**ADDENDUM NUMBER ONE, Page 1**

Maintenance Bldg Remodel  
GRAYS HARBOR TRANSIT  
Hoquiam, Washington

October 12, 2023

project number	19-12F
date	10.12.2023
file name	1912F PSEFinal
drawn by	ACG
title	Addendum 1
1 of 1

**PARTIAL DEMOLITION  
UPPER PLAN**

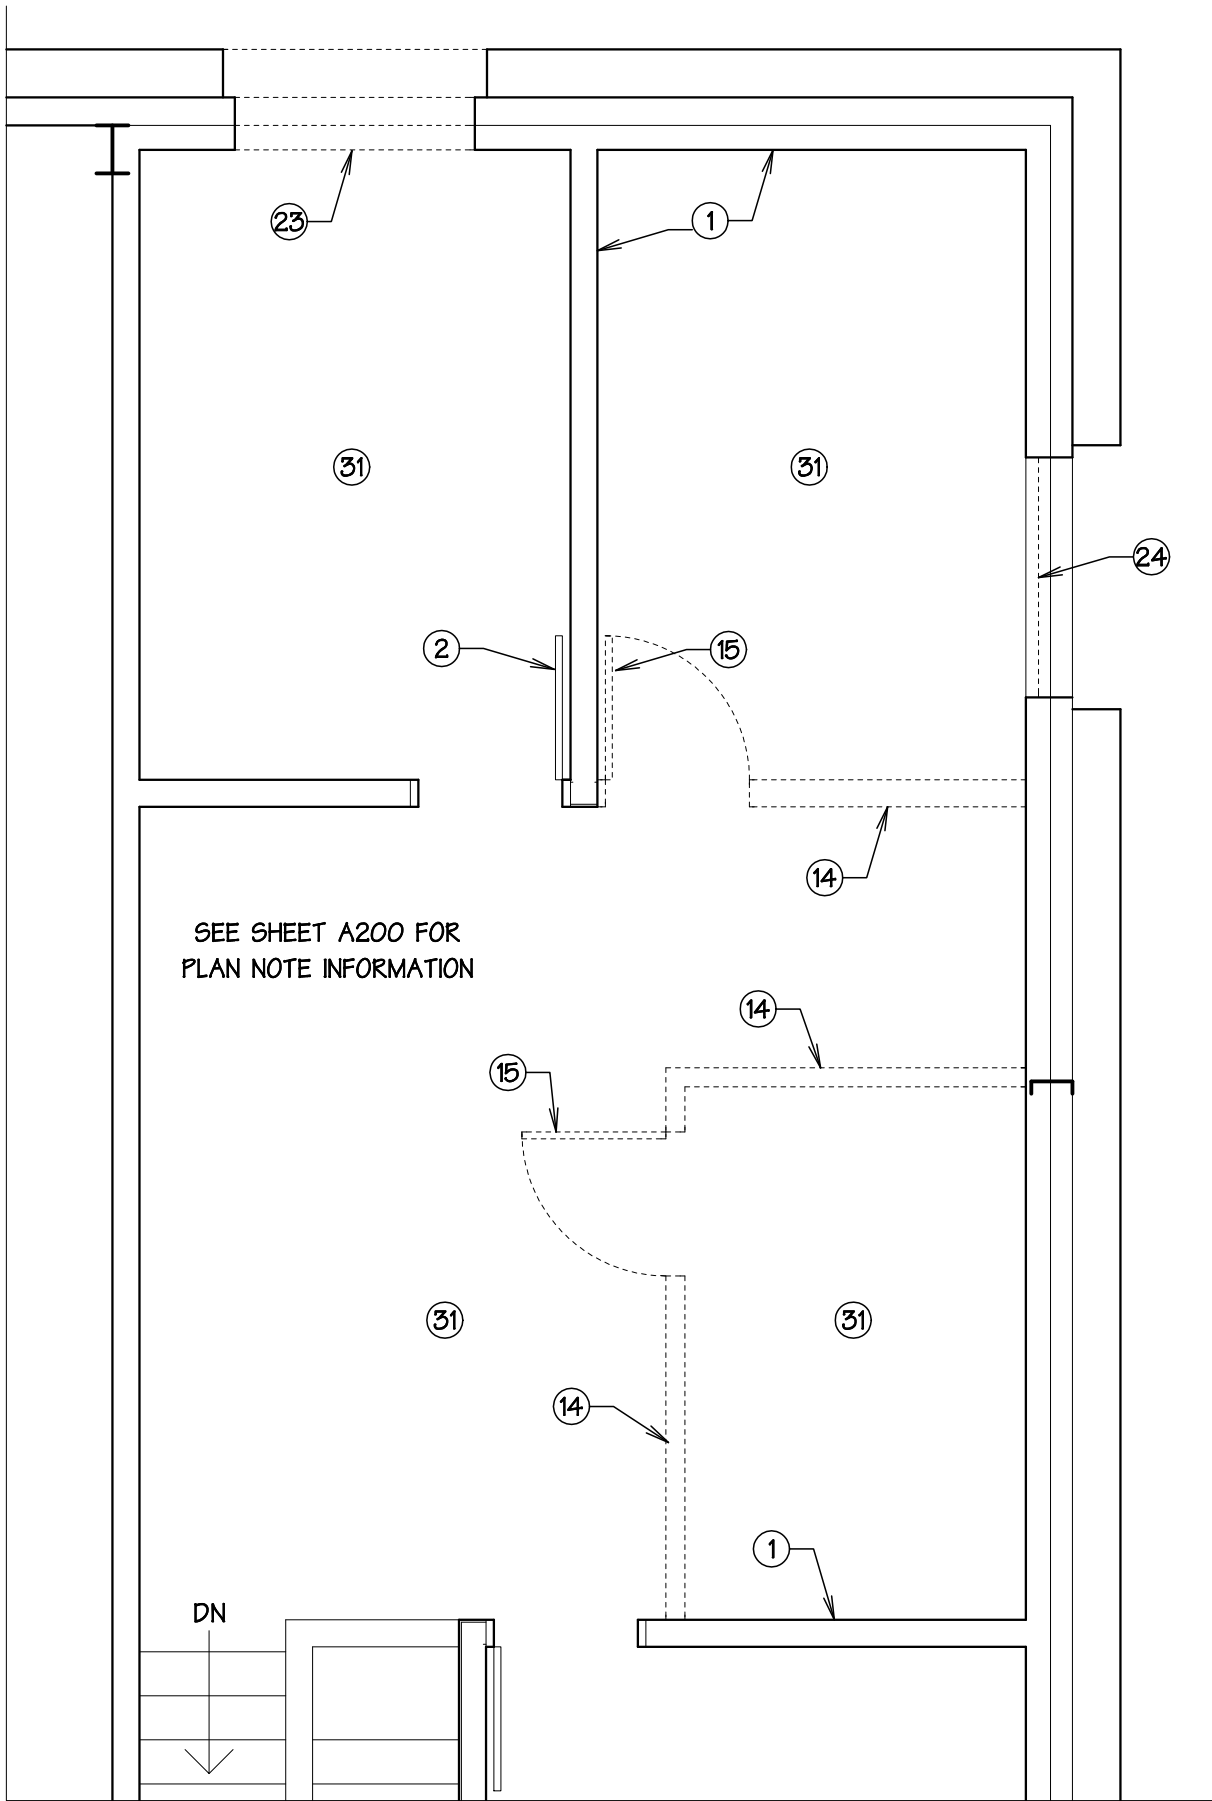
- A. Sheet A200, Demolition Floor Plans & Notes.
  - 1. Training-206 – Remove Notes 31 & 32. Existing flooring to remain.
  - 2. Storage-207 – Remove Note 31. Existing flooring to remain.
  - 3. Driver Lounge-106 – Note 21. Note to read "Remove existing plumbing fixture. Modify existing rough opening for new sink".
  - 4. See attached Partial Upper Plan for added demolition scope.
- B. Sheet A300, Room Finish Schedule.
  - 1. Training-206 – Change Floor Finish to "Existing Carpet Tile". Change Base to "Existing Rubber". Remove Remark Notes 3, 5 & 7.
